UCC24612 Waveform: Voltage between VD (5 pins) and VS (2 pins)

- TI-EVM:UCC28780EVM-002
- C3=220p、R3=56Ω

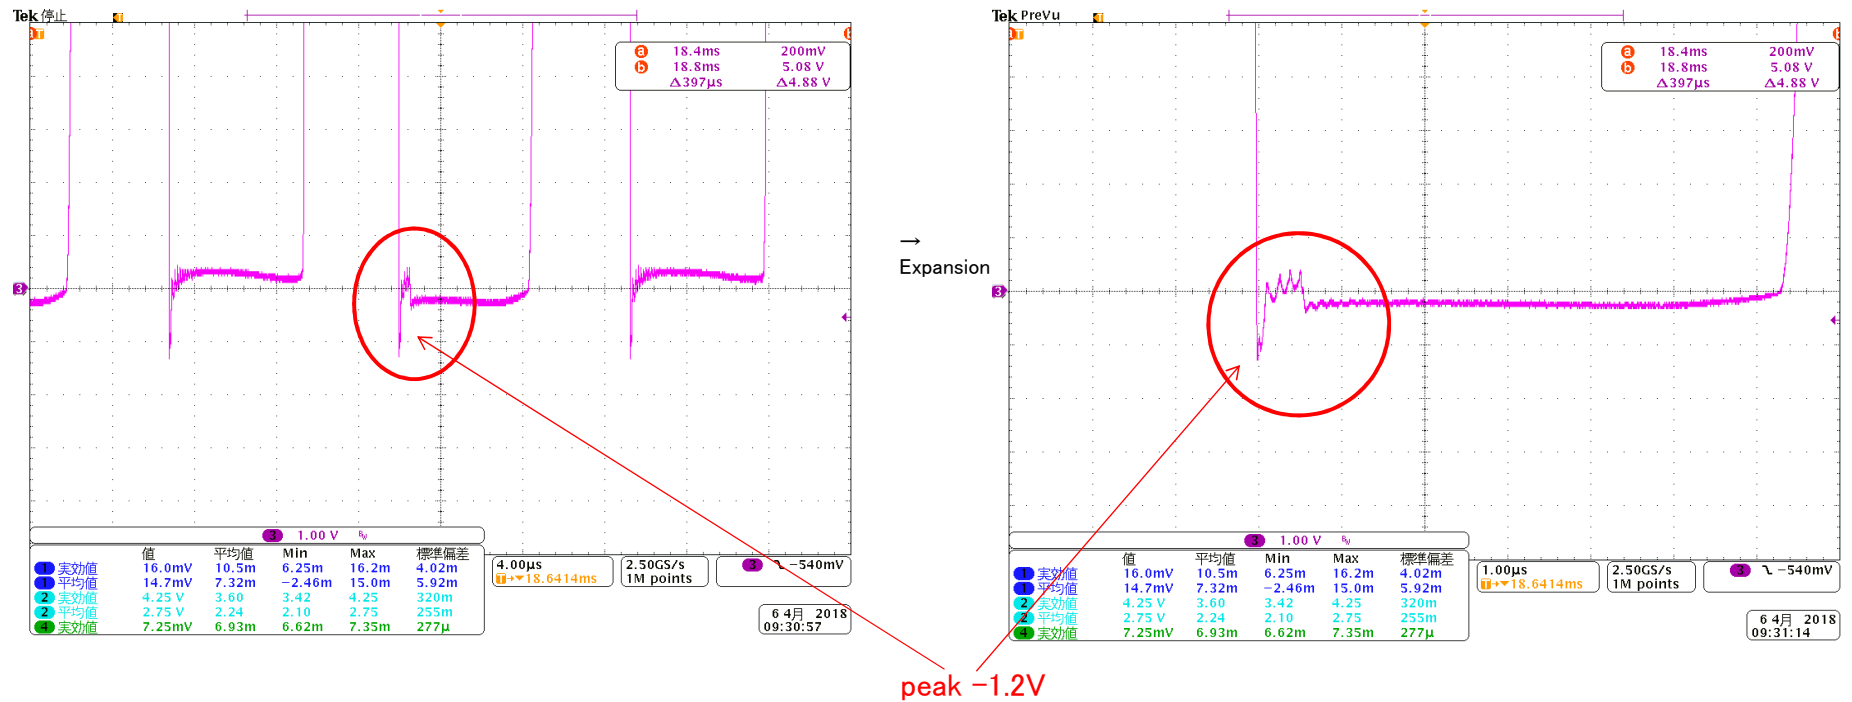
- The absolute maximum rating of the VD pin is -0.7 V. When measured, the value will be -1.2 V or more. Will this be okay?
- In case of NG, please tell me the measure.
